MEMORANDUM

From:	Built Heritage Officer	Service:	Green Infrastructure
Application No.	260979	Site Visit Made:	Yes (12/05/26)
Address:	The Old Cottage, Pearson Road, Sonning, RG4 6UH.		
Proposal:	Application for submission of details to comply with Condition 4 (structural repairs method statement) of listed building consent 232278 dated 09/01/2024.		
Relevant built heritage condition text.	4. Except for the opening up works previously specified, works are not to be undertaken to make structural repairs to historic timbers and masonry work to each of the building's elevations until a method statement outlining the nature and extent of the repairs to be undertaken for each individual elevation has been submitted to and approved in writing by the local planning authority. Structural works are then be undertaken in accordance with the details as approved.

Figure 6. Elevation of the west gable with constituent elements of the timber frame indicated

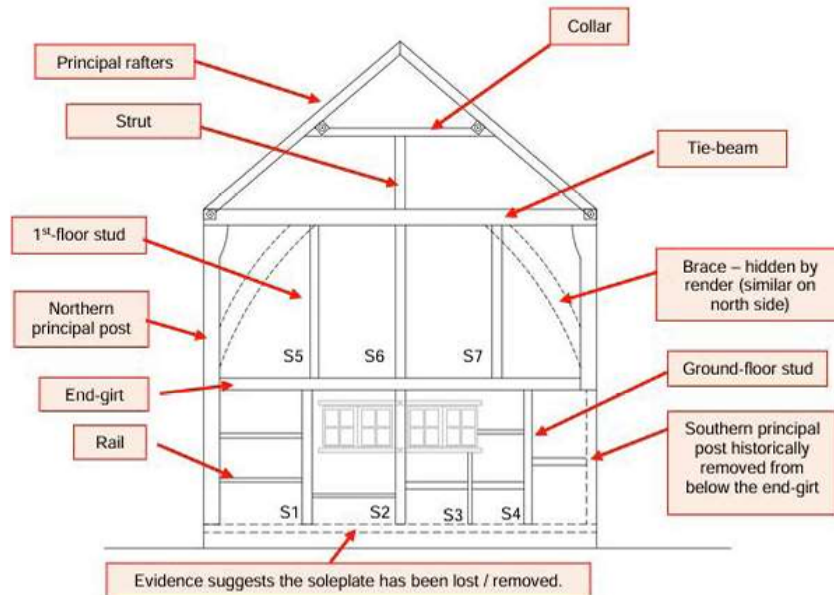
The Clive Hudson structural report on the west gable identifies secondary studs 1-4 as the vertical timber studs at the ground floor between the 'end girt' (see Fig.1 for reference).

Extract from Heritage Revival Method Statement – here it should be noted the braces at first-floor level previously hidden under the cementitious render finish have now exposed along their lengths (along with directly adjacent brick infill) as a result of the render covering them. Furthermore, removal of the existing render covering for the southern principal post appears shows the lower portion severely eroded rather than having been historically removed.
